Technical Service Bulletin

Transaction No.: **2081781/1**

55 Water in luggage compartment - leak in rear lid bump stop

Figure 1. Cross-section of bump stop 83H.827.499.

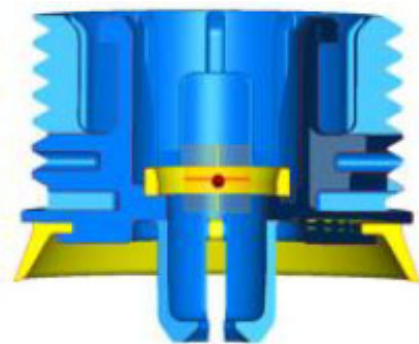
The bump stop 83H827499 is secured with a spreader rivet in a square hole. Deviations in the installation process may result in the required contact pressure not being attained by the seal around the bump stop.

Process optimization and component optimization (additional double-sided adhesive tape) were implemented at the factory in week 43 / 2025. The optimization was incorporated into bump stop 83H827499A.

- Remove both bump stops 83H827499 and clean the contact surfaces. Also make sure that the bonding surface is free of grease.
- Then install the new bump stop 83H827499.A by fitting the spreader rivet correctly and attach the additional double-sided adhesive tape.
- Remove the luggage compartment side trim panels and luggage compartment floor panels to expose the body. Dry the affected areas in the luggage compartment and the panels.
- Then install the panels that were removed previously.
